5. Libenthal Subdivision 2024 Addition KPB File 2024-086 Johnson Surveying / Needs, Muller, Crowder Location: Reid Street

ITEM #5 - PRELIMINARY PLAT LIBENTHAL SUBDIVISION 2024 ADDITION

KPB File No.	2024-086
Plat Committee Meeting:	September 9, 2024
Applicant / Owner:	Rick Needs of Soldotna, Alaska / Gary & Lela Muller of Sterling, AK / Keith Crowder of Soldotna, Alaska
Surveyor:	Jerry Johnson / Johnson Surveying
General Location:	Caribou Hills

Vicinity Map

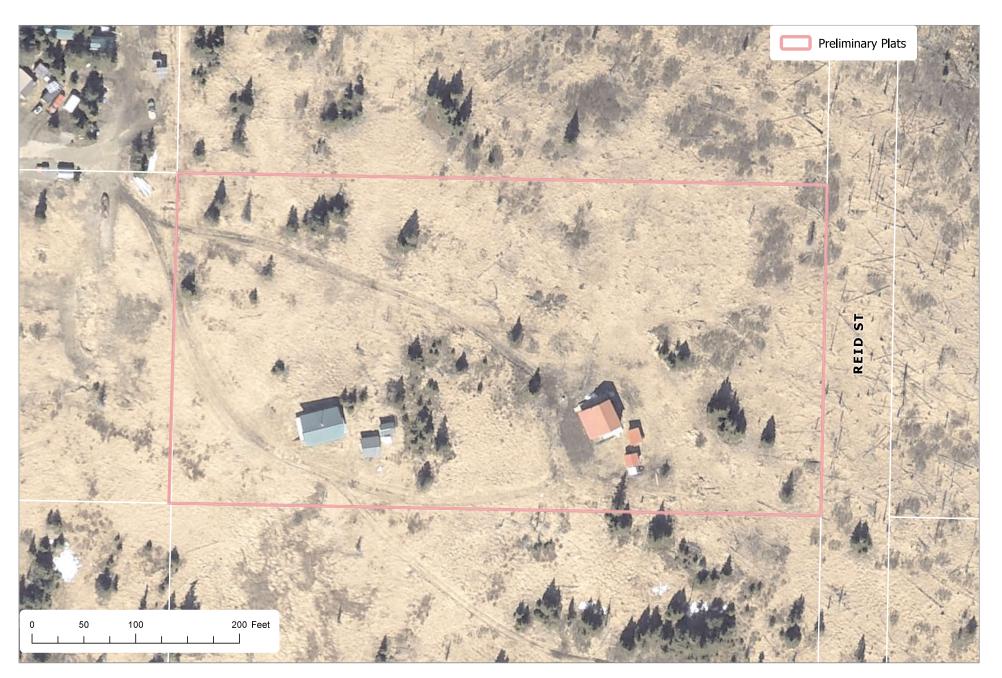
Oil Well Road is two words in the vicinity map
